PlanGrid Task Report - Jun 3, 2025

13 tasks in this report.

#350 [CNTL 012] [NEW] CRITICAL (BAS) – Wiring specification.

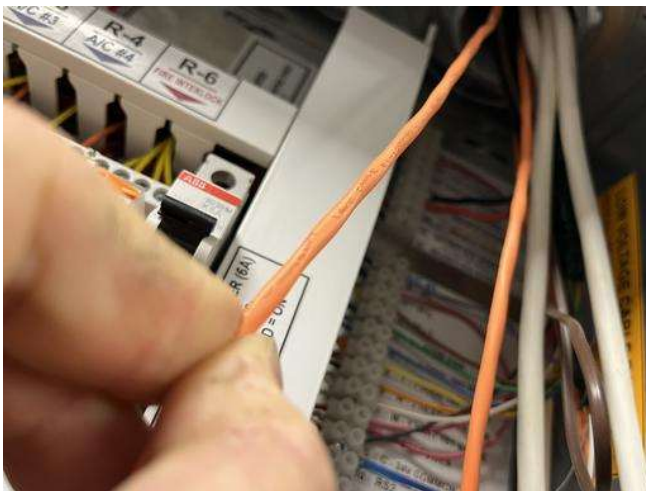
Description
AC1, AC2, AC3, AC4 temp.
sensor wiring installed is
Lake Cable brand. Plans call
for specifically
W221P-2003NT.

No documentation provided

Nevermind, I see the note on #351
